**Our Reference:** LU23281-LTR-01 (Rev A)

**Council Reference:** MCUC 2025\_5845/1

**Re: Response to Further Issues Letter – Material Change of Use-Code  
Childcare Centre and Community Facilities - Place of Worship)**

36 Front Street, Mossman  
Lot 1 on RP706244

**MOSSMAN UNITING CHURCH**  
**PROPOSED HALL & OSHC**  
**PROPOSED CIVIL ENGINEERING WORKS**  
**STORMWATER CATCHMENT PLAN: PRE-DEVELOPMENT**  
36 FRONT STREET, MOSSMAN QLD  
THE UNITING CHURCH IN AUSTRALIA

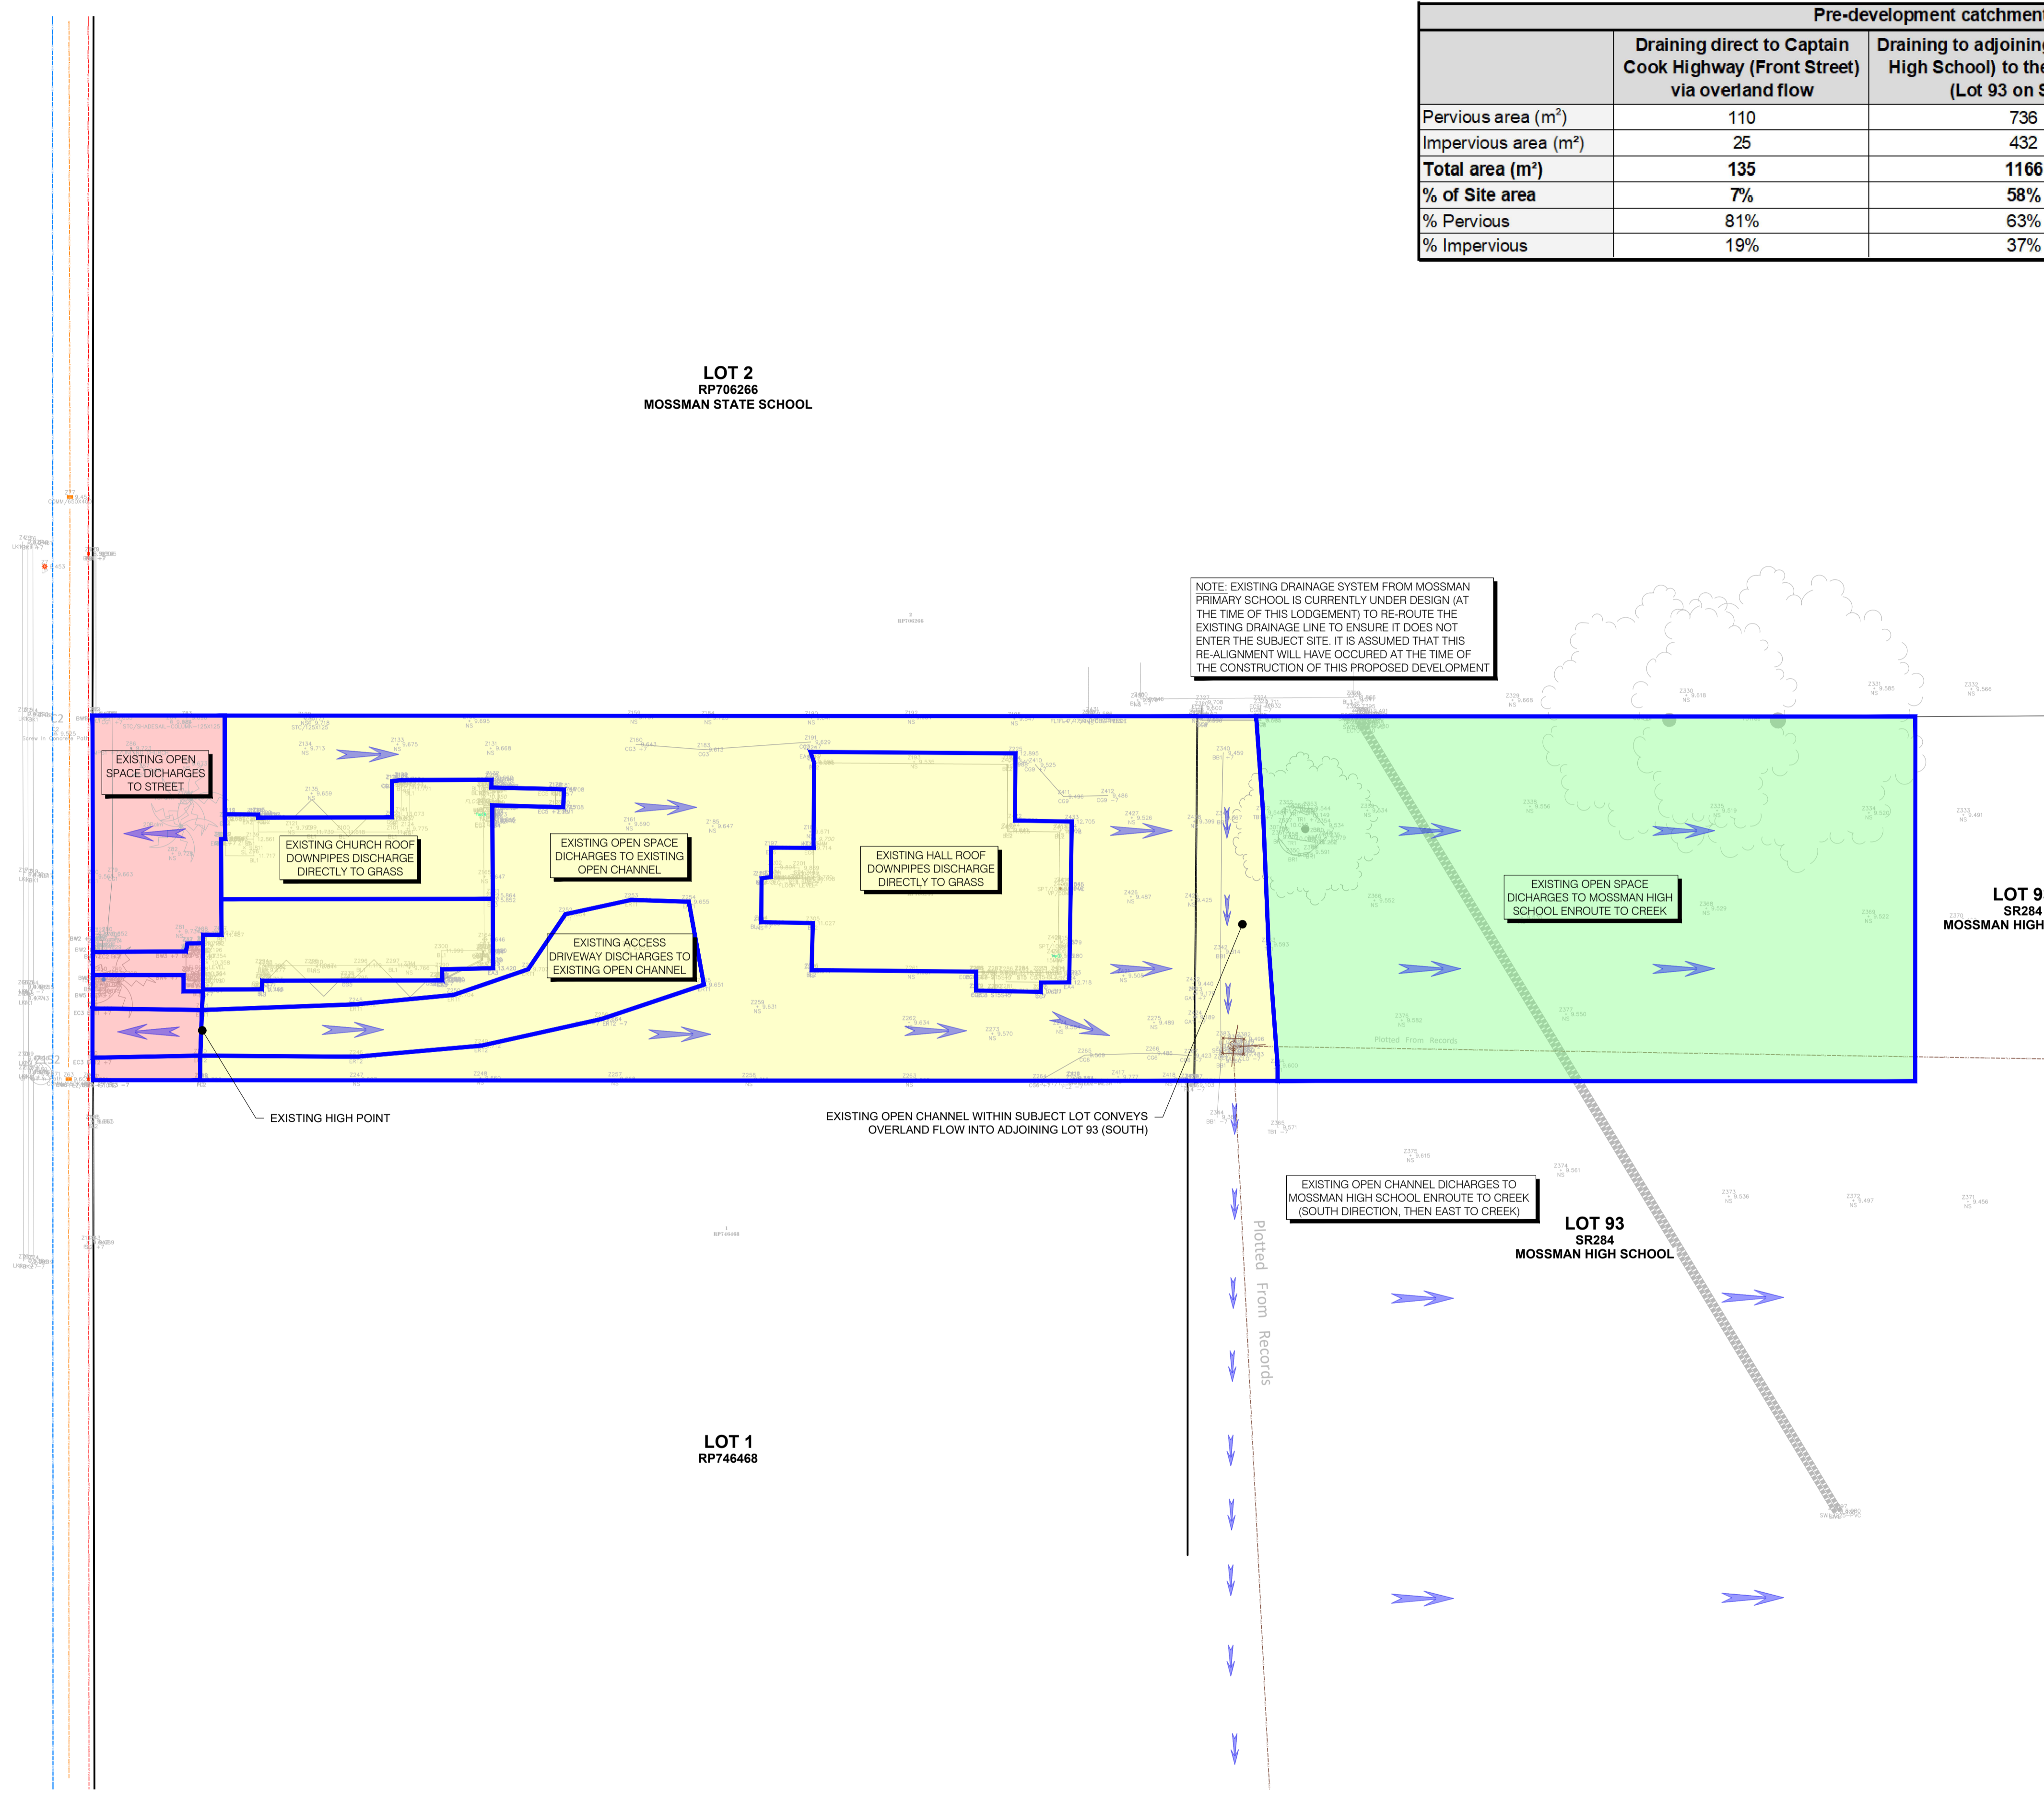
Council raised concern that the adjoining allotment to the south does not constitute a lawful point of discharge for the development, and that the proposed stormwater design results in an increase of captured and concentrated flows being discharged onto that allotment.

- The lawful point of discharge for the subject site is the existing open grass-lined channel discharging to the Mossman High School property to the south and east of the site (Lot 93 on SR284). This discharge arrangement exists under pre-development conditions and is maintained under the proposed development.

- Under existing conditions, site stormwater is conveyed as sheet flow across the site, progressively concentrating as it traverses in a west-to-east direction in accordance with the site's natural topography. This overland flow is ultimately concentrated and collected by the existing open channel, which conveys flows southward to the lawful point of discharge.

- DRAINS hydrologic and hydraulic modelling confirms that post-development peak flows to the lawful point of discharge are less than pre-development flows across all design storm events — including the 5-year, 10-year, and 100-year ARI events — with the proposed On-Site Detention (OSD) measures in place. The modelling results are summarised below.
